REGIONAL REVIEW FINDING

ARC REVIEW CODE: R509302

Submitting Local Government: Cobb County
Name of Proposal: The Mill at Covered Bridge Expansion

Preliminary Report:	Sept 30, 2005	DEVELOPMENT OF REGIONAL IMPACT REVIEW REPORT	Project:	The Mill at Covered Bridge Exp #911
Final Report Due:	Oct 30, 2005		Comments Due By:	October 14, 2005

GRTA DRI SITE PLAN

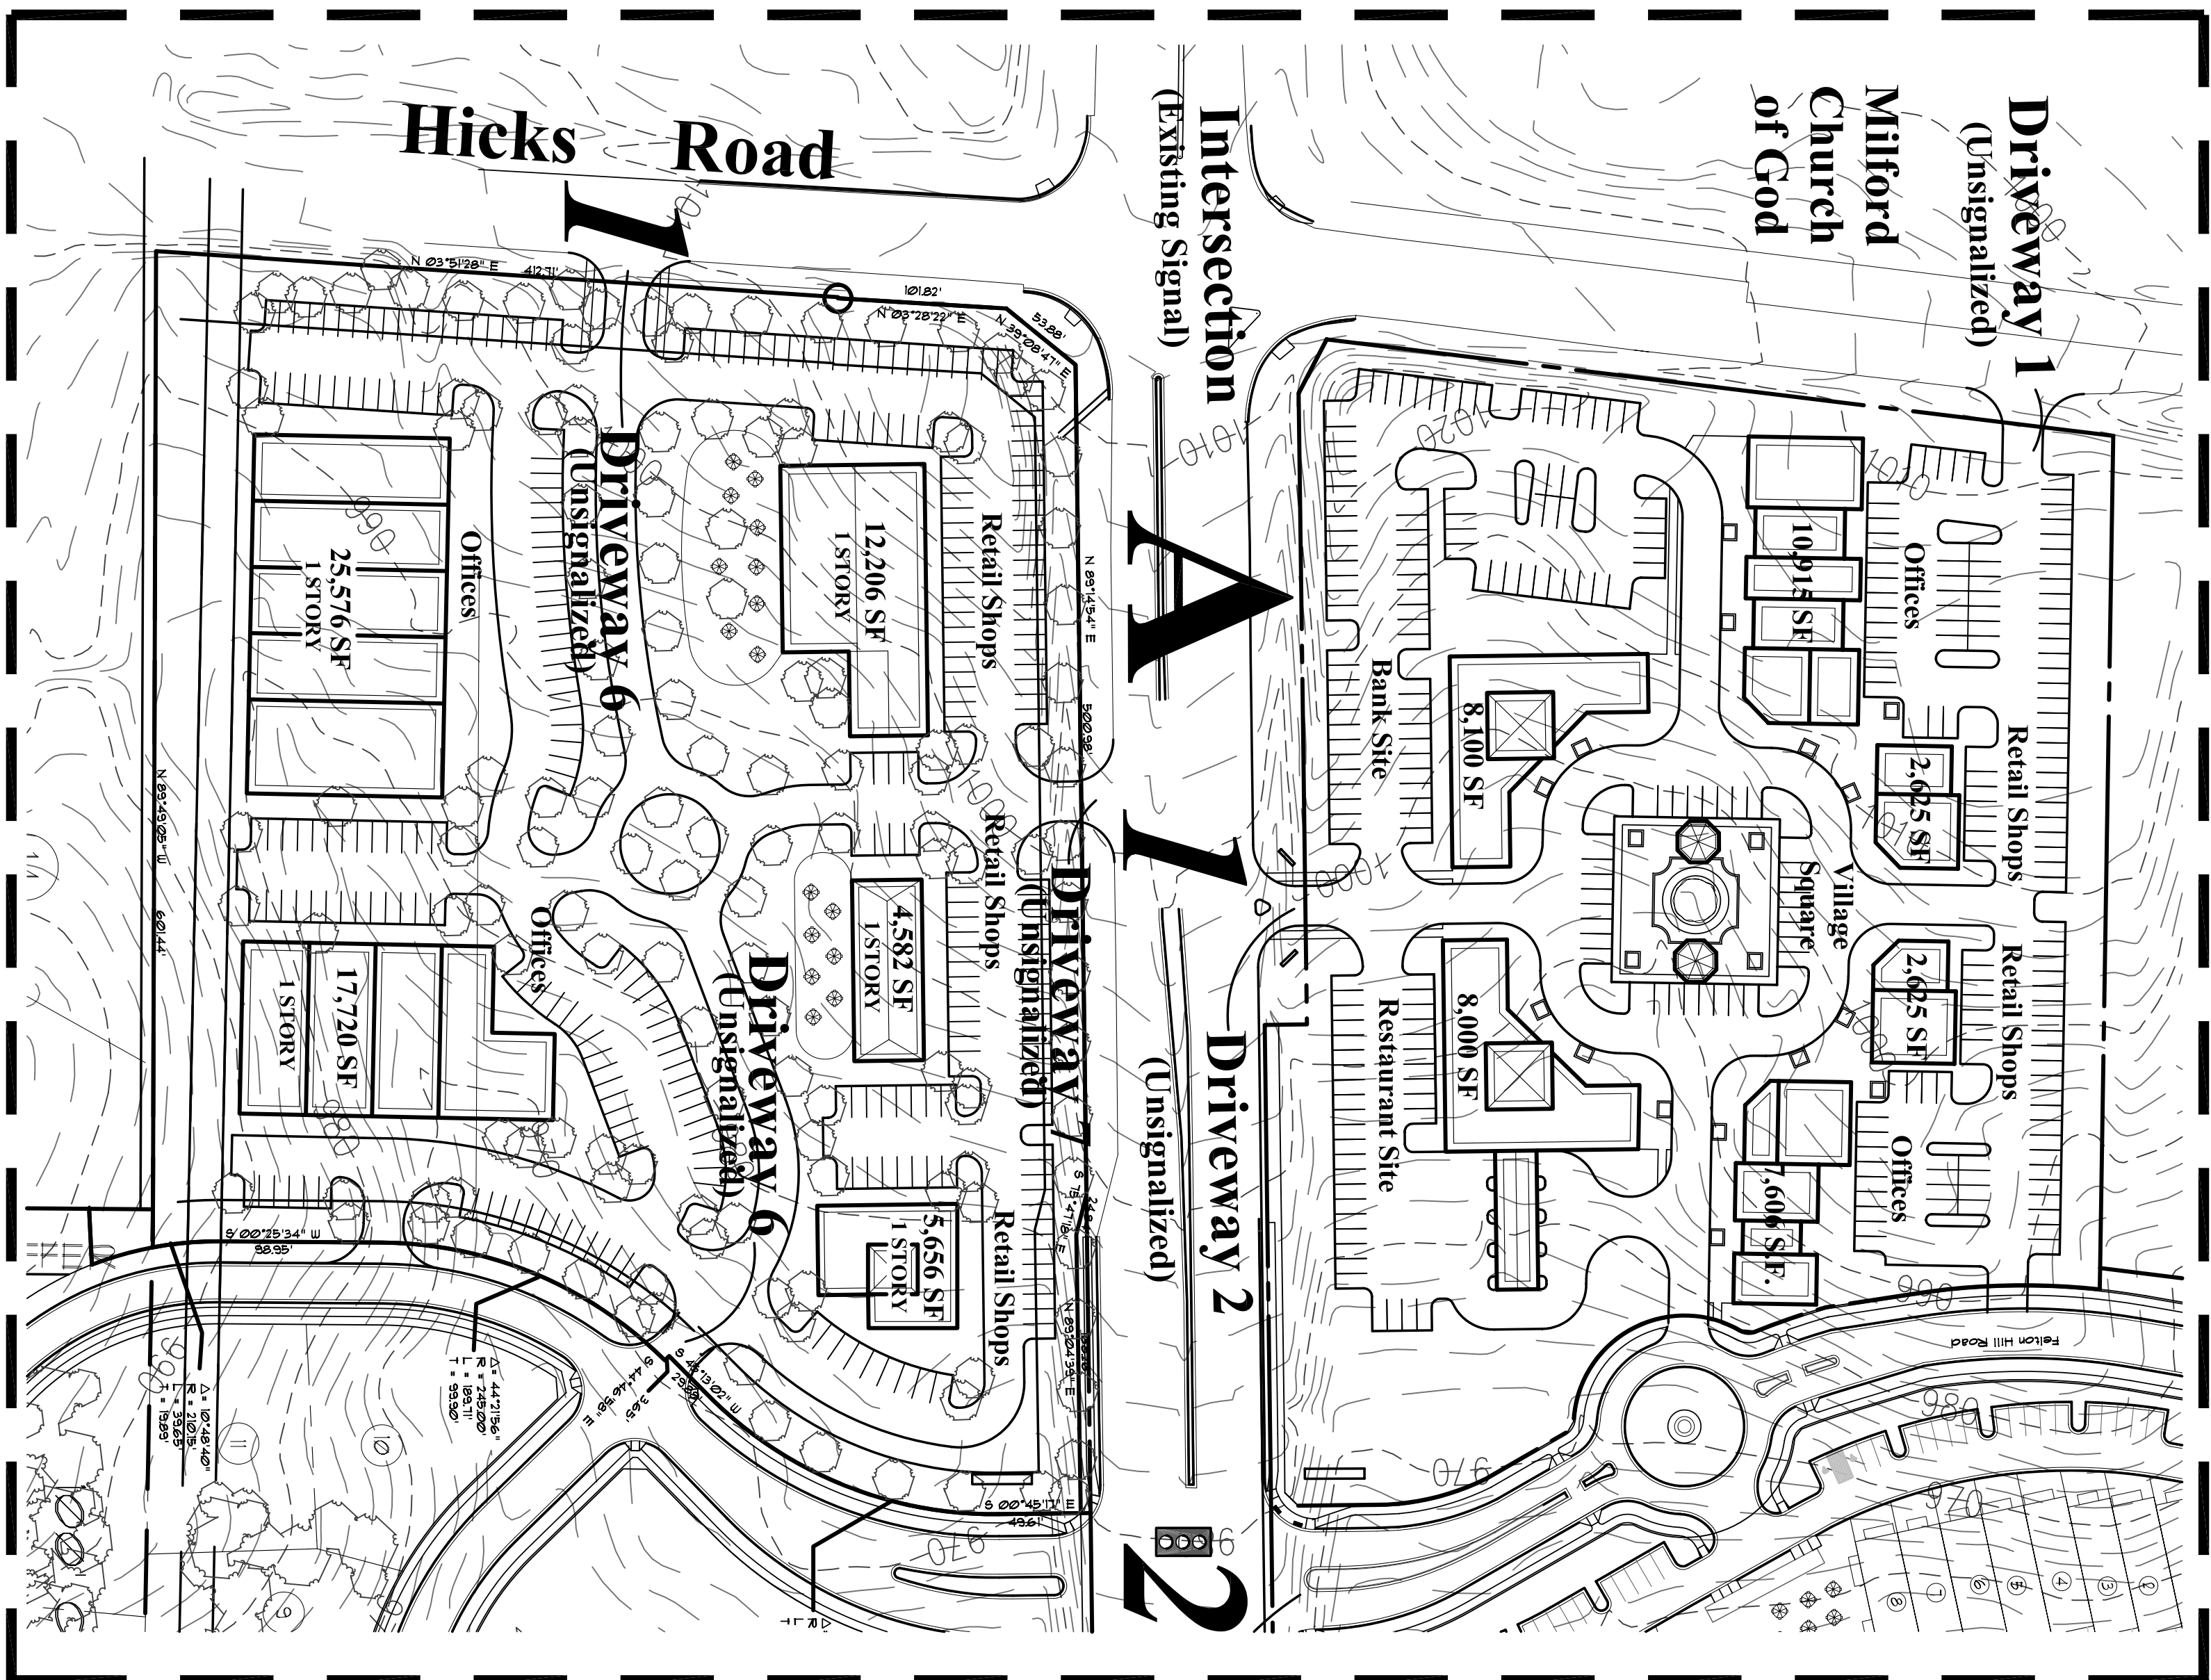
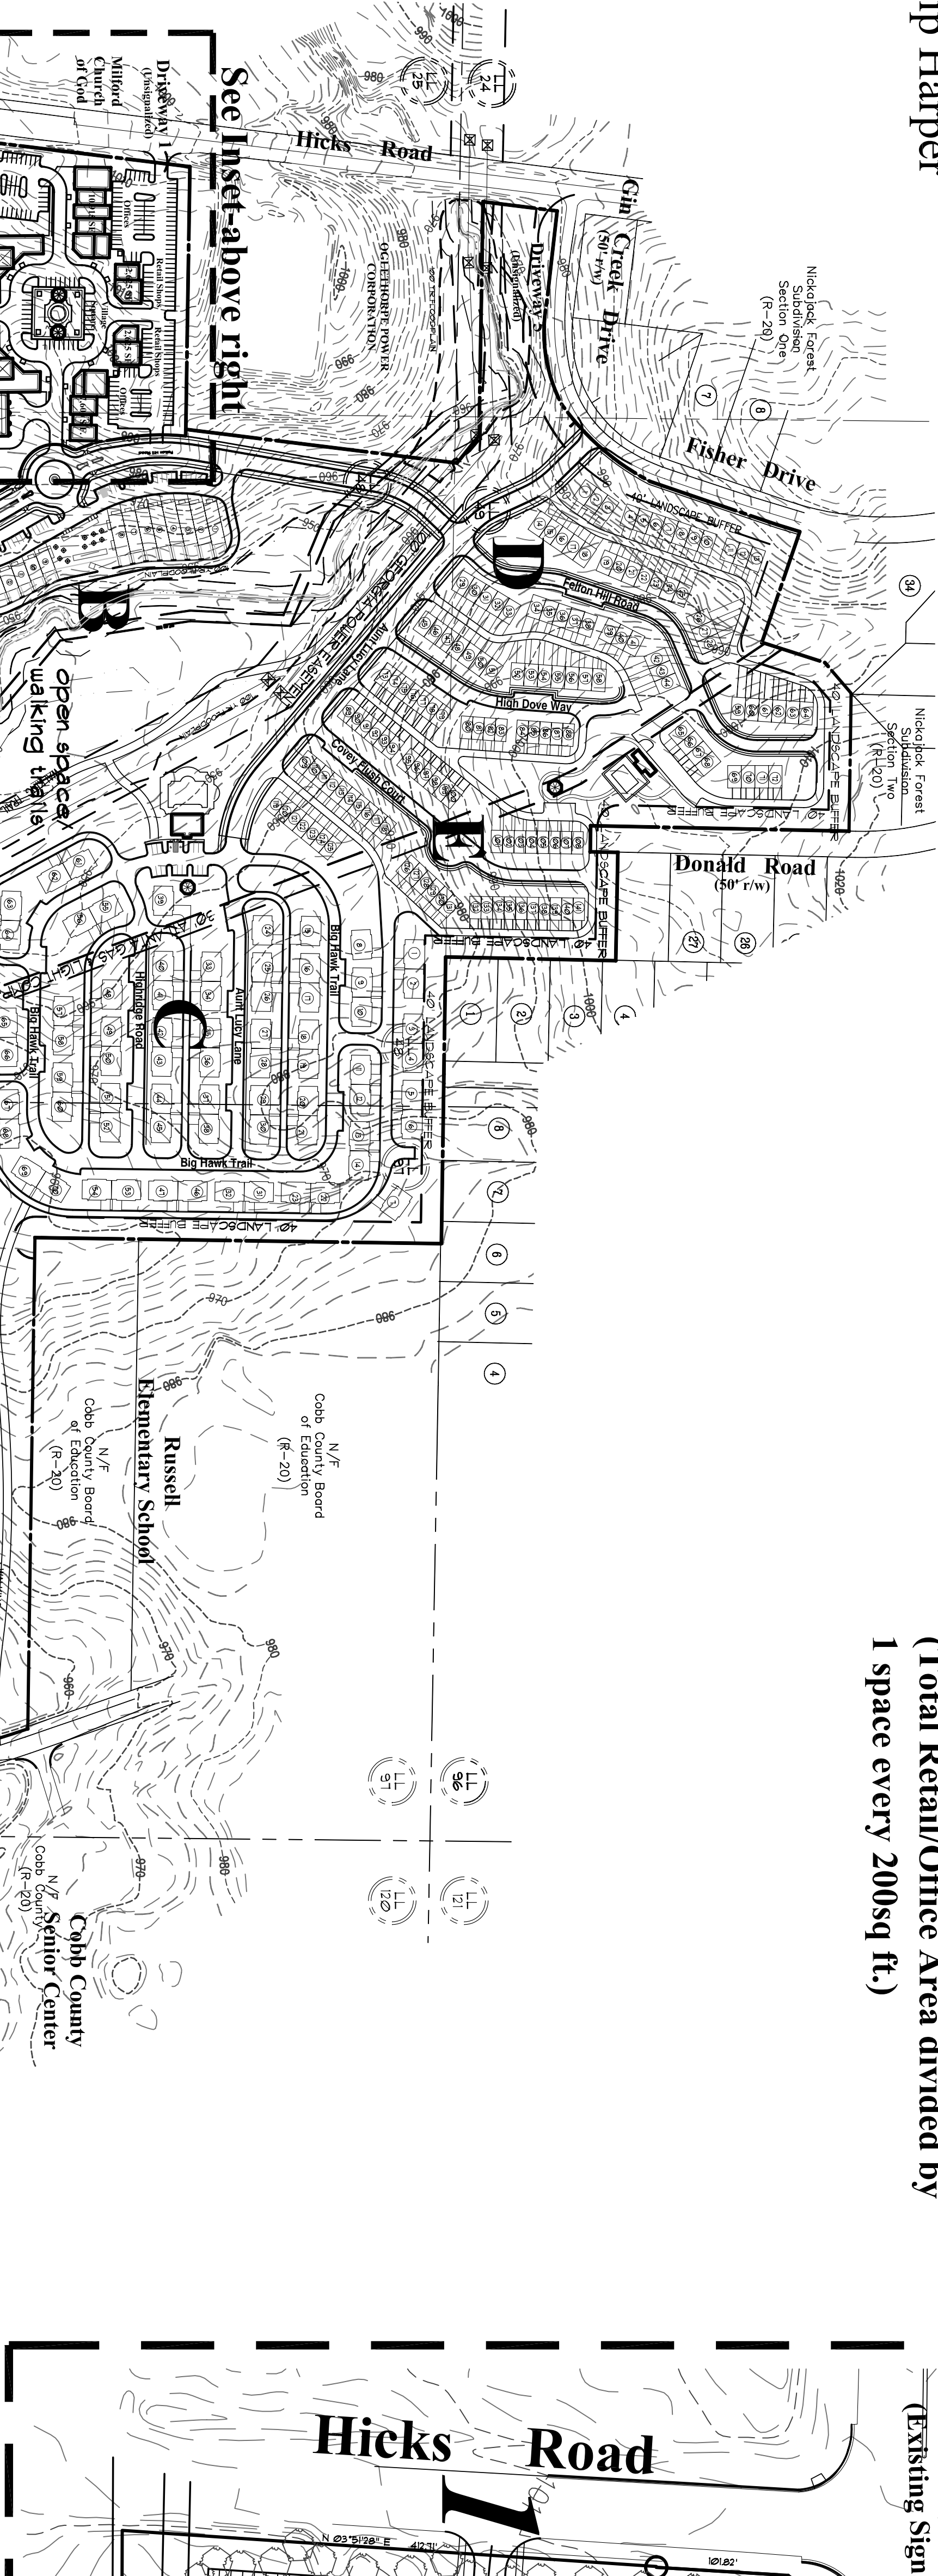
Additional Comments: The proposed expansion provides good connections to the residential portions of the site that are located adjacent to the proposed expansion. Minimizing the appearance of parking from Hicks Road and East West Connector is strongly encouraged. Safe and convenient pedestrian access should be provided throughout the parking areas.

The proposed expansion provides good connections to the residential portions of the site that are located adjacent to the proposed expansion. Minimizing the appearance of parking from Hicks Road and East West Connector is strongly encouraged. Safe and convenient pedestrian access should be provided throughout the parking areas.
